Mulliniks Construction Co., Inc.

File No. 7775036-002AC, 7775037-002AC, 7775038-002AC

Re: File Nos. 7775036-002-AC, 7775037-002-AC, & 7775038-002-AC Mobile Concrete and Asphalt Material Crushing Units

The Department has reviewed your application for permits to construct three mobile concrete and asphalt material crushing units that was received in this office on October 7, 1997. We need the additional information/clarification listed below to process this request.

PLANT D: CP04 200 TPH --WATER SPO1 G2 POWER PRIMARY CRUSHER UNIT PC1 150 HP 510 F02 1 CONVEYOR •1 WATER SP02 G3 POWER GENERATOR 300 HP SECONDARY CRUSHER SCI \$08 1 -WATER SP03 F05 GI **SCREEN** CONVEYOR •2 POWER STECKPILE S1 UNIT 600 HP FO4 F07 -WATER SP04 CONVEYOR *3 STOCKPILE

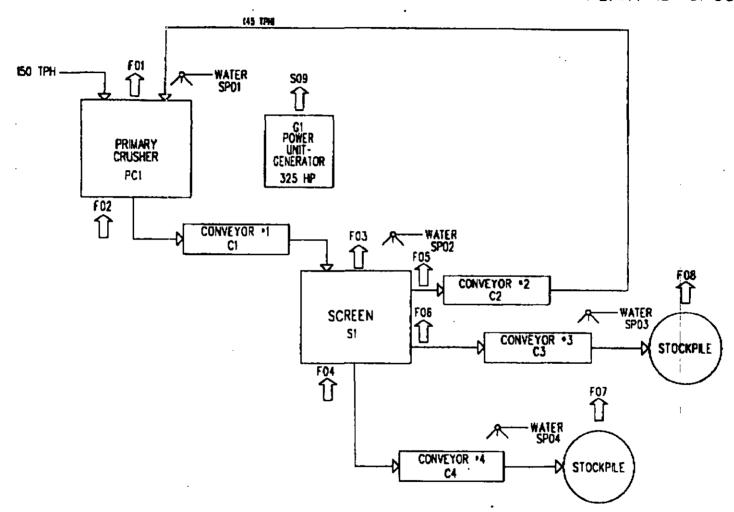
- 1. List the key components of the facility. Give make and model number of the equipment when available.
- 2. Provide a process flow diagram and brochure, if available, on the crusher system.

- 1. The list of components for each crusher unit is shown on Attachment 1.
- 2. Process flow diagram for each crusher is attached.
- 3. Attachment 2 identifies fugitive dust control measures.
- 4. Attachment 3 shows the fugitive dust emission for each crusher.
- 5. The unit can be operated in accordance with sub part 000 and rule 62-296.71 FAC where applicable. The 5% standard should be imposed only in areas that are subject to the rule.
- 6. Attachment 4 provides the required O&M schedule.
- 7. Copy of the existing air construction permit for Duval County is attached.
